NON-CONCURRENCE PROCESS

TITLE OF DOCUMENT Confirmatory Action Letter - Oconee Commitments to Address External Flooding Concerns	ADAMS ACCESSION NO. ML103280043
DOCUMENT SPONSOR Meena Khanna / George Wilson (NRR/DE)	SPONSOR PHONE NO. 301-415-2150
NAME OF NON-CONCURRING INDIVIDUAL Jeff Mitman	PHONE NO. 301-415-2843

**STAFF RESPONSE TO NON-CONCURRENCE ON THE INITIAL STARTING RESERVOIR
LEVEL OF THE JOCASSEE DAM FOR THE FLOODING INUNDATION STUDY OF THE
OCONEE NUCLEAR SITE FOR DEMONSTRATING REASONABLE ASSURANCE**

Figure 1: Jocassee Spillway

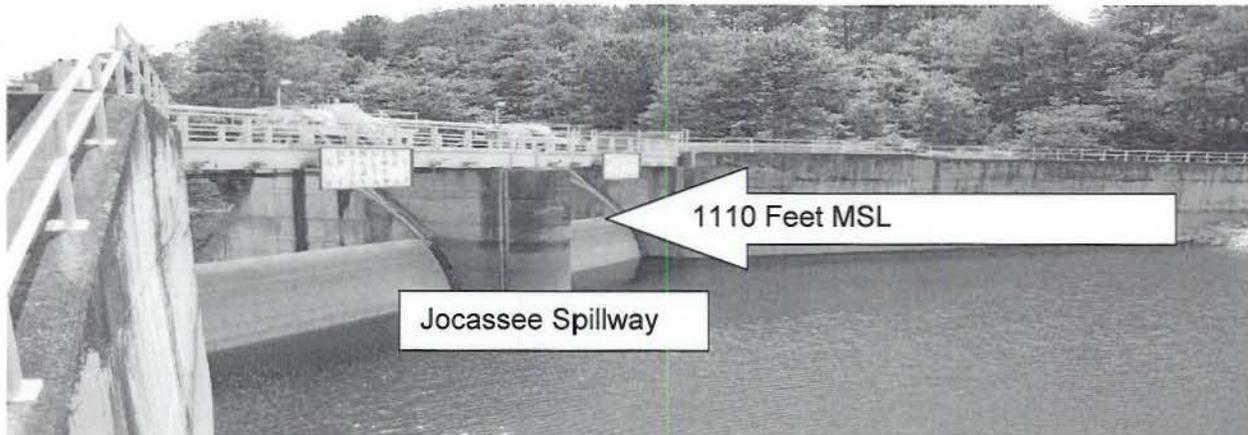
FERC has stipulated the normal operating range of the Jocassee Reservoir as 1080 to 1110 ft msl. The Keowee Reservoir has a normal operating range from 794 to 800 ft msl. FERC also approved the random sunny day failure analysis at a starting reservoir of 1108 ft msl for the Jocassee Reservoir in the 1992 FERC Study performed by Duke Energy. The same rationale applies for the Keowee Reservoir level for being below the top of the operating band. Duke Hydro operates the dams in accordance with the "Keowee - Toxaway Project High-Water Operations Process" procedure. The procedure covers normal and contingency actions for the operation of the dams, specifically the control of the reservoir levels. The contingency actions include lowering the reservoir levels for abnormal rises in lake level and any anticipated significant precipitation. The normal operating pool level of the Jocassee Dam Reservoir is 1108 ft msl, which is 2 ft below the top of the two spillway flood gates, which are at an elevation of 1110 ft msl. Any water level above this elevation would flow over the top of the two spillway flood gates (see figure below). In addition, the maximum allowable operating level during the hurricane season is reduced to 1108 feet msl, to account for any unanticipated sudden heavy

rainfall. This would be the same rationale for the Keowee Dam except it has four gated spillways at 800 ft msl.
